MBHP_OPL3 module modifications, the 5V option

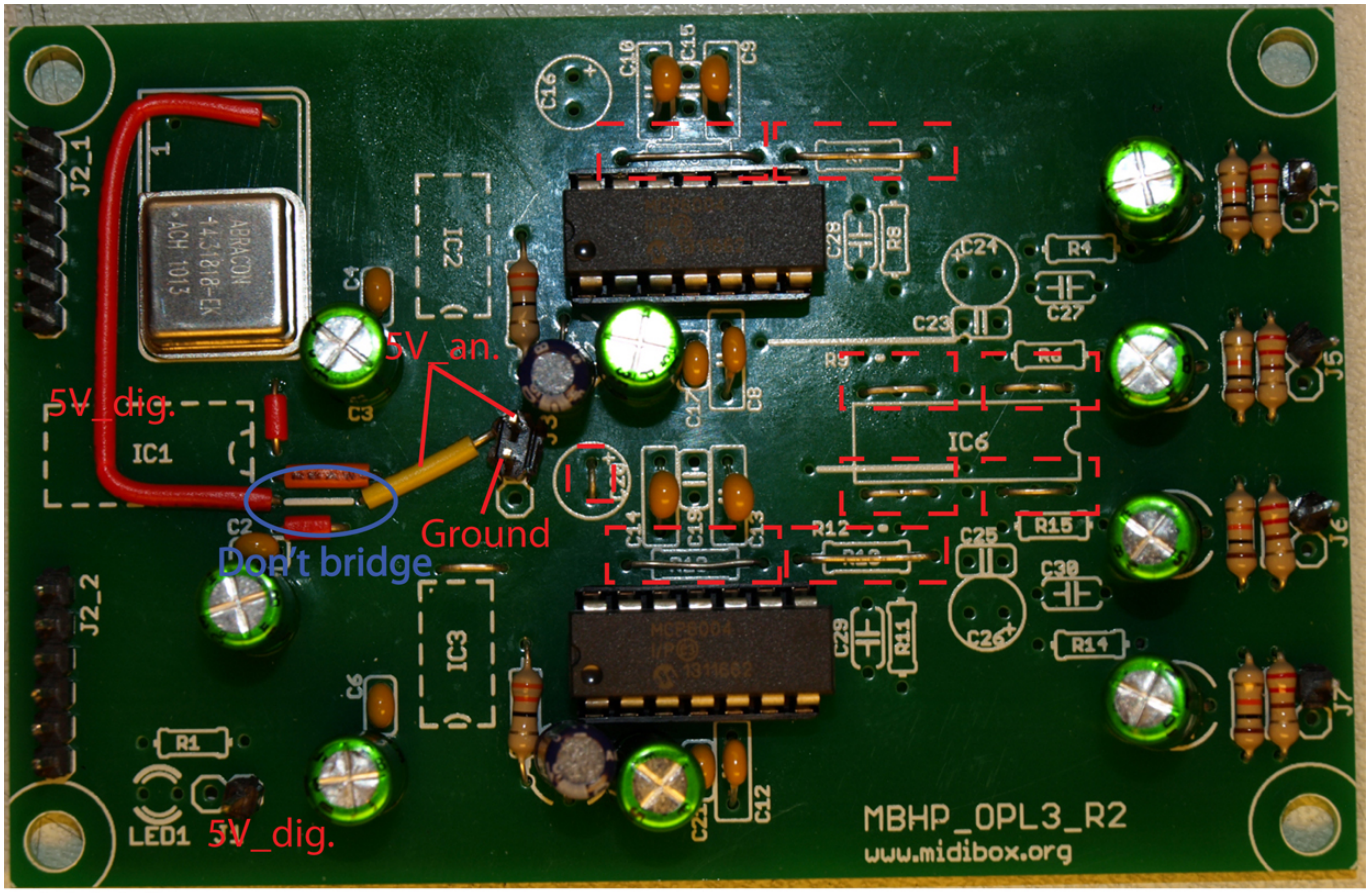
- Replace R5,R7,R10 and R13 with jumpers
- Bridge IC6 pads 1&3, 5&7, 8&10 and 12&14
- Leave out:
IC6
R4, R6, R8, R9, R11, R12, R14, R15
C15, C16, C19, C20, C23-C30
- Bridge C20 pads (to supply Ground for the op-amps)
- Leave out bridges to IC6
- Use MCP6004 for IC3 and IC5
- Supply 5V to the +12V pin, and Ground to Ground

This way the second buffering stage is left out.

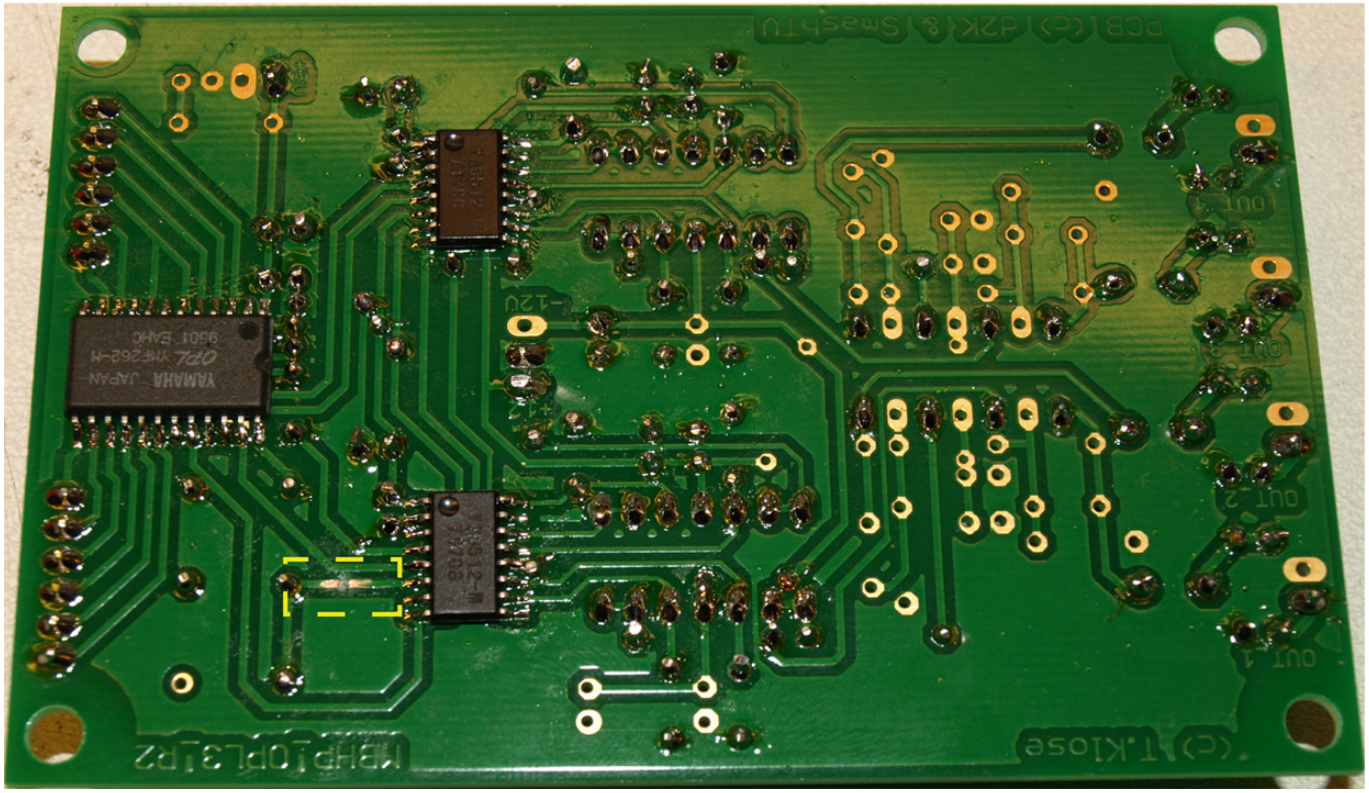
- Cut the trace between the 5V pin of the Oscillator and the DAC
- Leave out the middle horizontal bridge from IC1
- Connect the right pad of this bridge to the 5V pin in the middle of the board with a jumper
- Connect the left pad of this bridge to the 5V pin of the Oscillator with a jumper
- Two separate 5V voltage regulators, IN pins connected through a ferrite bead
- One 5V source to Core and J1 of OPL3 module
- The other 5V source to J3 of OPL3 module
- Ground ONLY to J3!

Bridge

Cut trace
